April 2, 1993
LD-93-058

Docket No. 52-002

Subject: System 80+™ Fire Protection and Revised DSER Responses

Attached to this letter is information requested by the NRC staff on fire protection and other DSER items. The Attachment 1 material on fire protection was discussed at the meeting on March 3, 1993, and in subsequent telephone calls. The material in this attachment was sent directly to Mr. J. Holmes on March 26, 1993. The marked-up CESSAR-DC revisions will be printed as part of Amendment 0. It is, therefore, expected that the open items indicated in Attachment 1 can be closed.

Seconds
Pressure vs Time
Figure 6.2-37

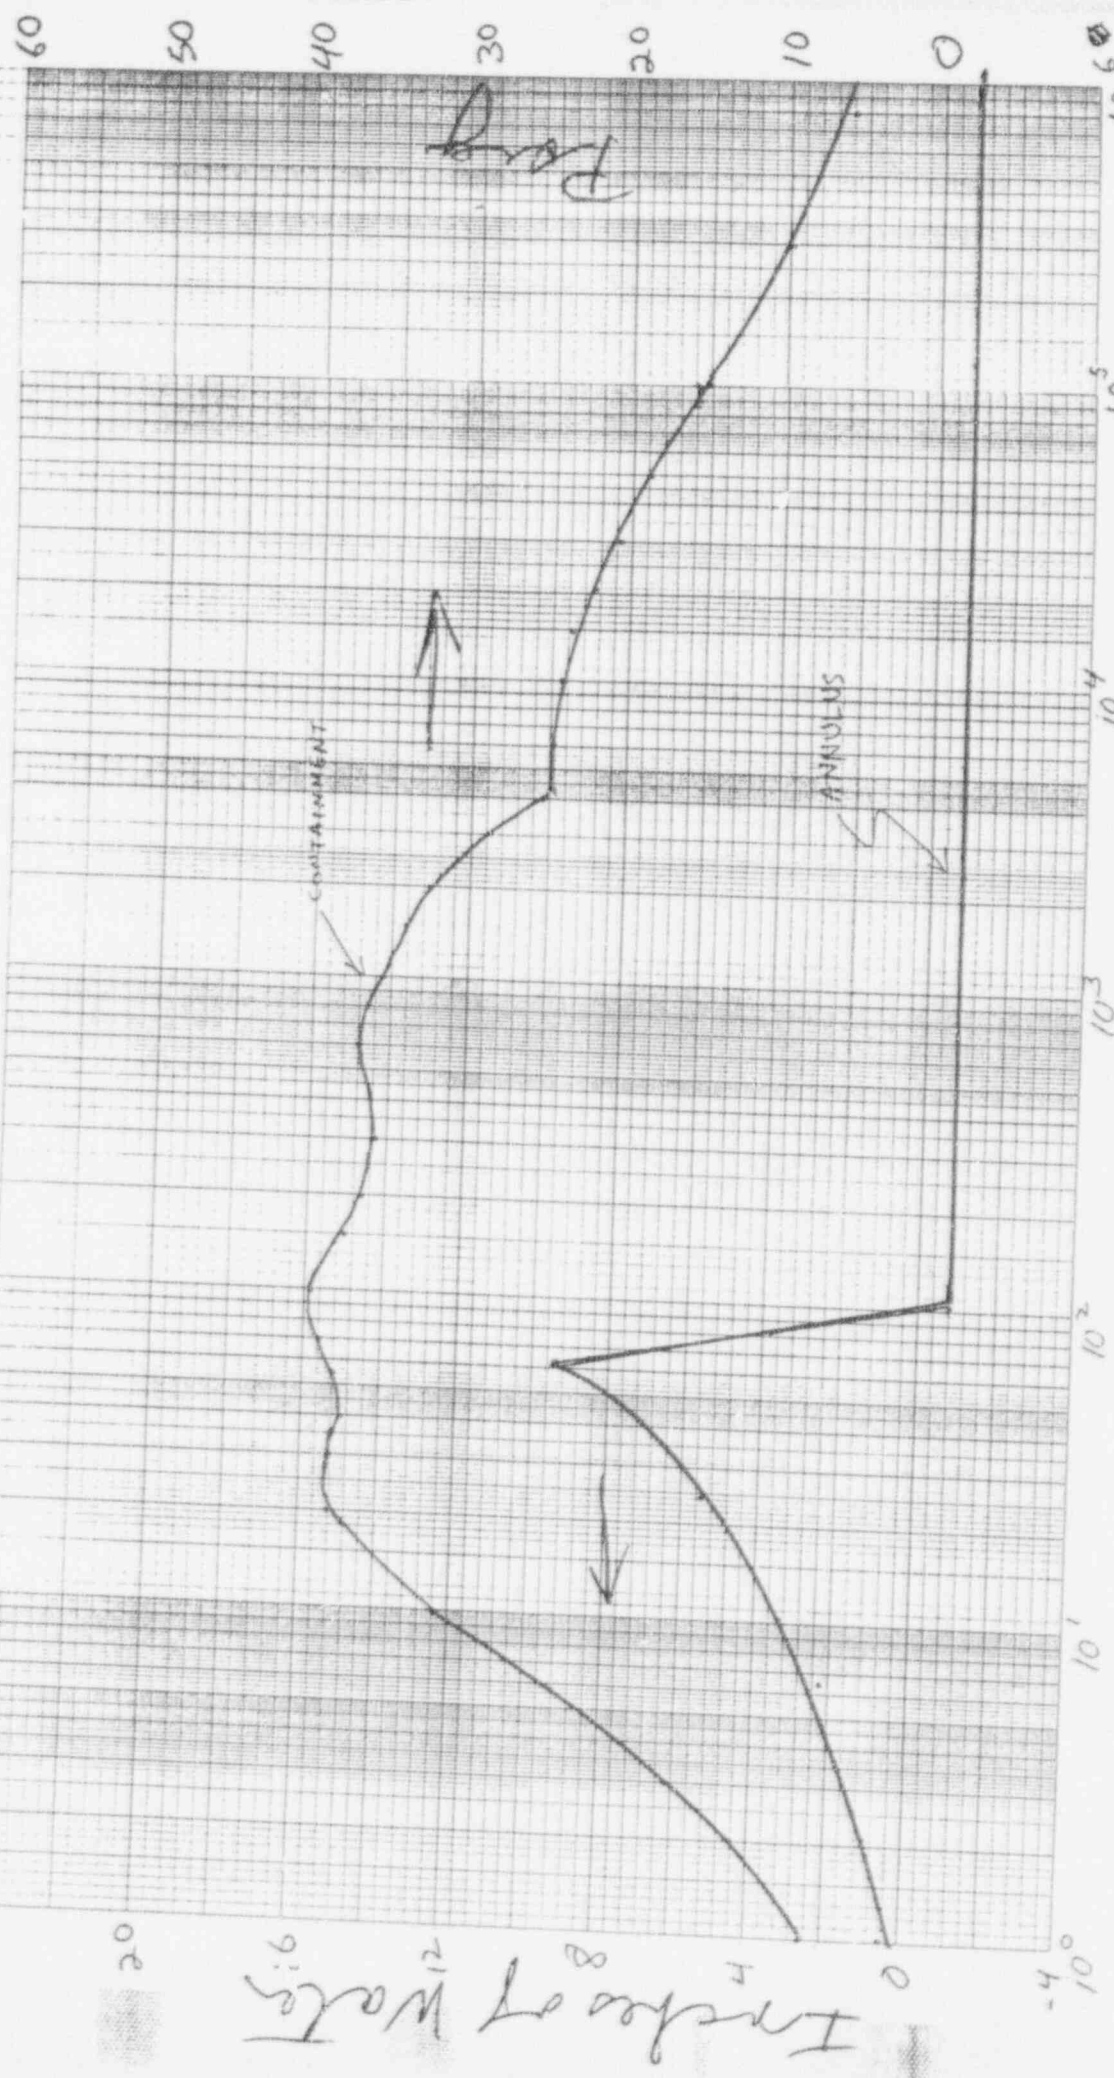
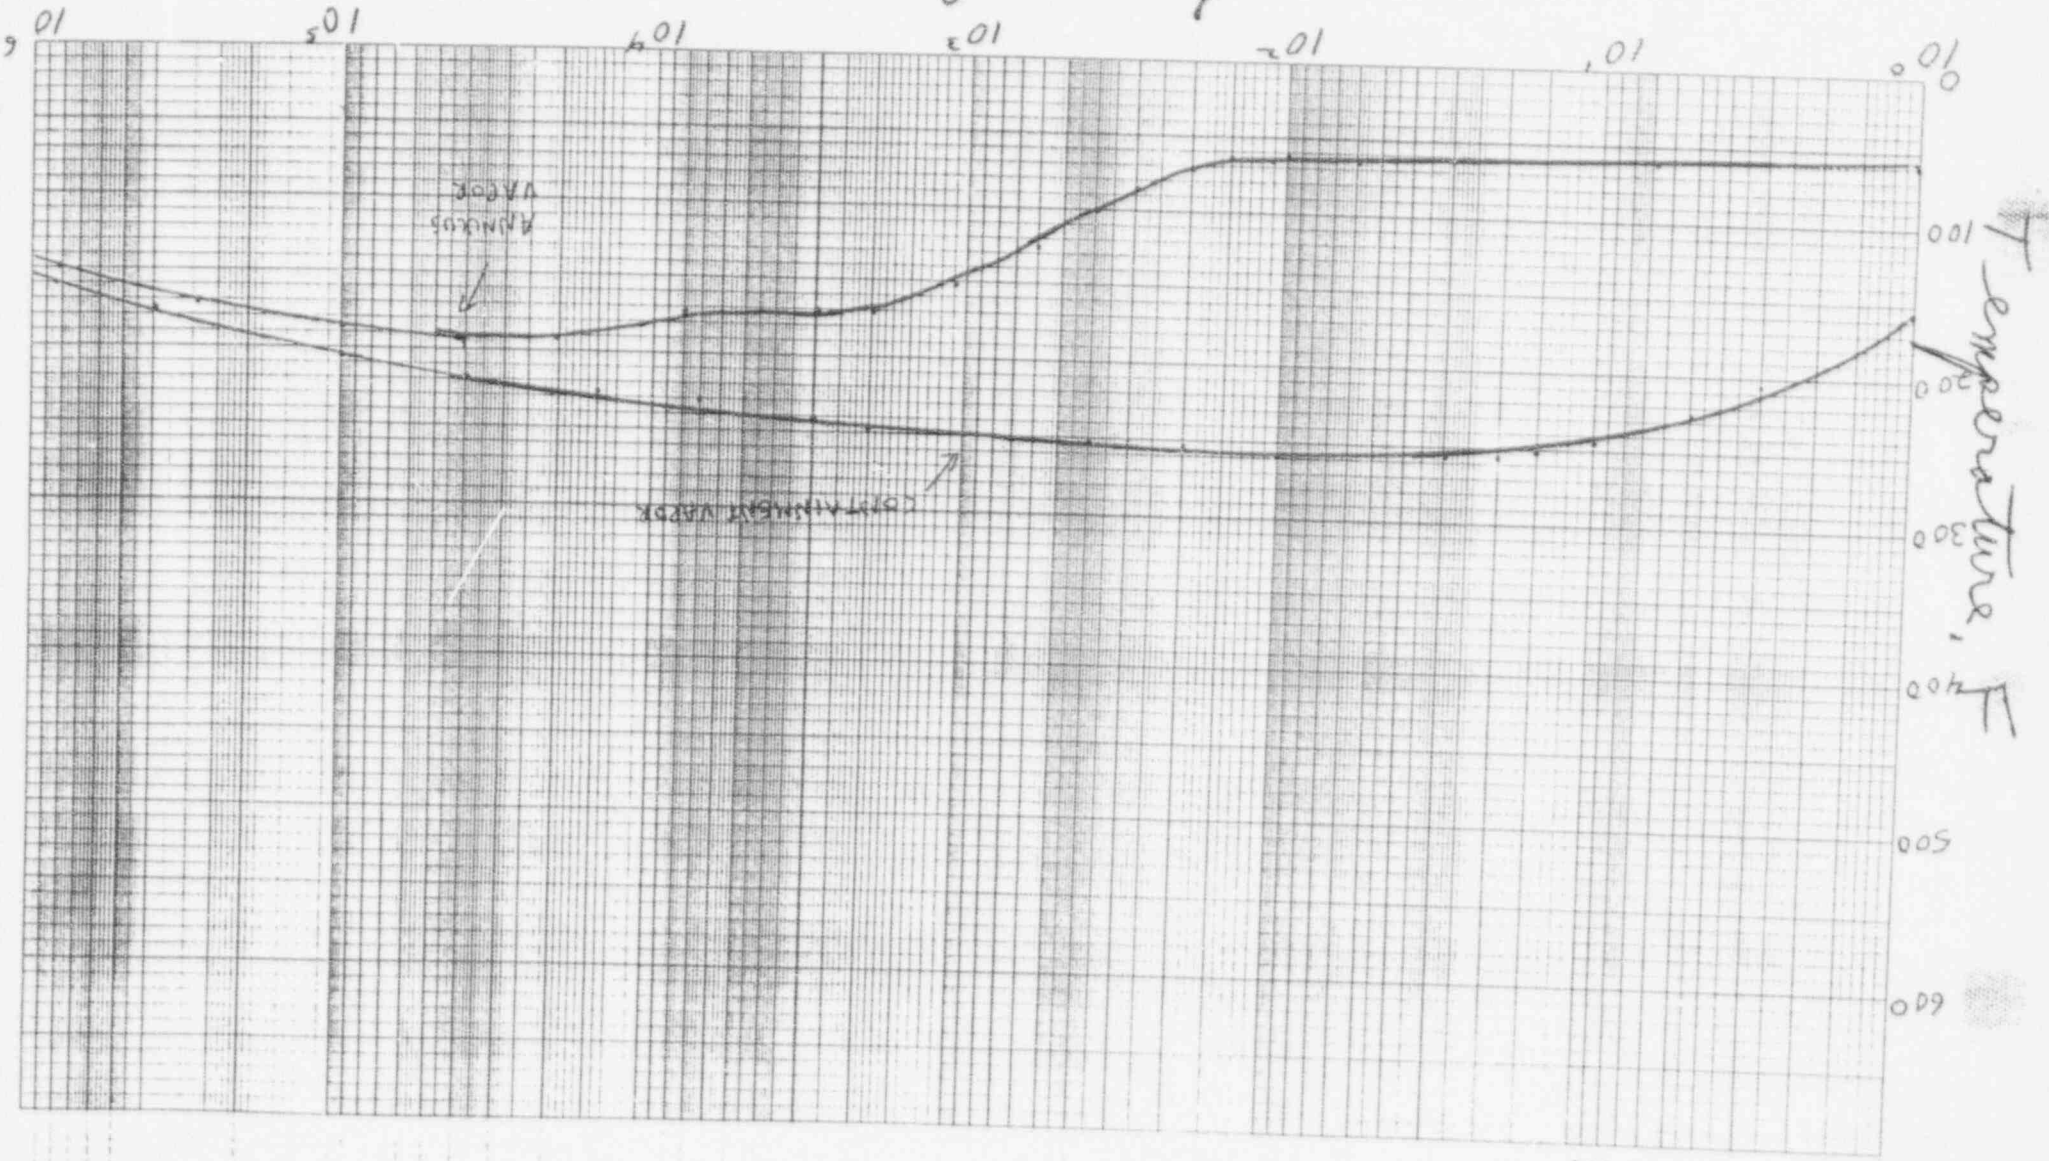
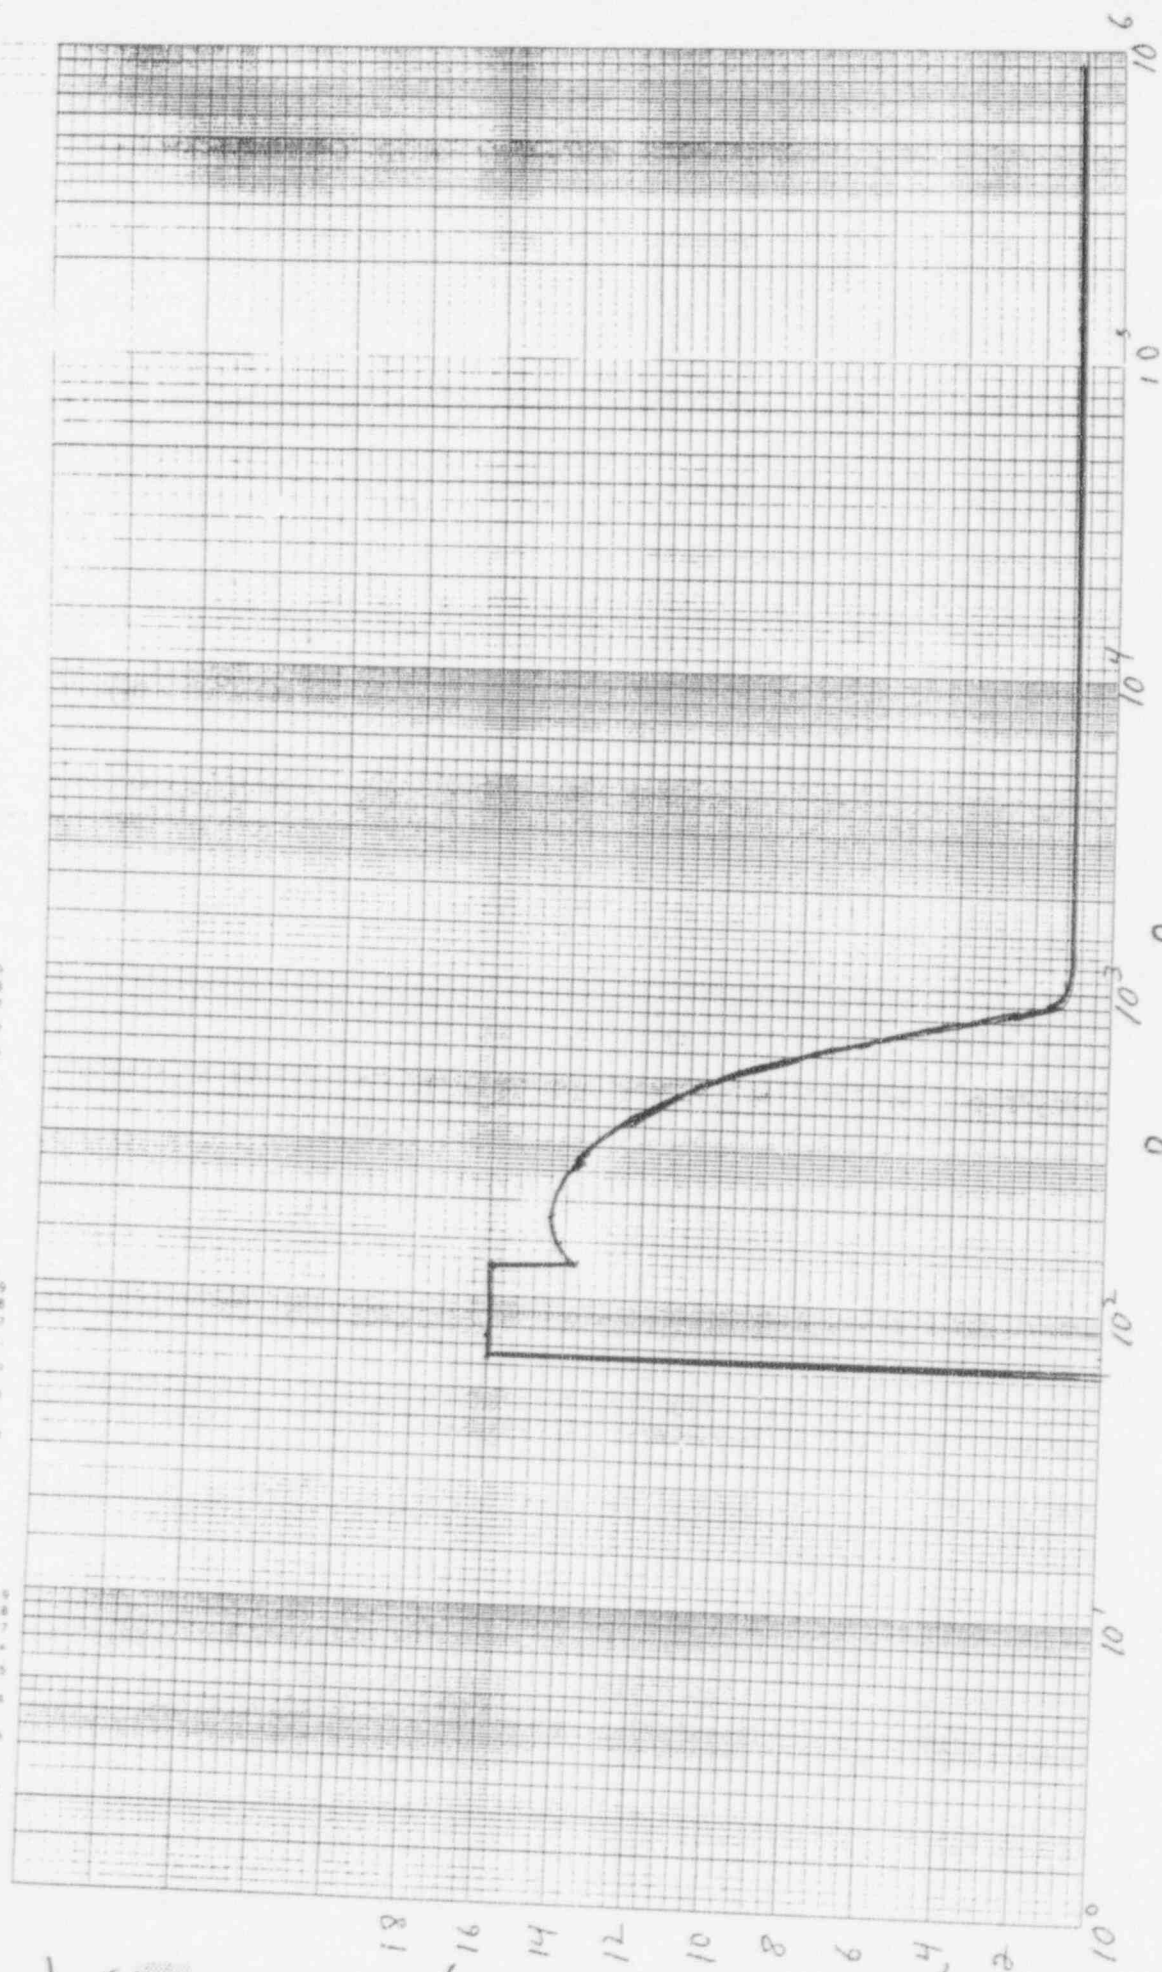
Attachment 2 provides a revision to open item 6.2.3-3 (SPLB) as a result of the increased power rating for System 80+. The results did not change significantly, and the corresponding revision to CESSAR-DC is being printed in Amendment N.

Figure 6.2.1-37 shows the annulus pressure and the corresponding containment vessel pressure versus time for the double-ended suction leg case. Figure 6.2.1-38 shows the annulus temperature and the corresponding containment temperature for this case. Figure 6.2.1-39 shows the exhaust rate of the Annulus Ventilation System corresponding to the annulus pressure shown in Figure 6.2.1-37. The annulus pressure reaches a peak of 8.80 inches of H₂O at 65 seconds and is negative after 100 seconds. The temperature in the annulus reaches a peak of 160°F after 13,750 seconds. *104* *9.30* *63* *195°F at 43000*

The analyses are based on a nominal core power of 3914 MWt.
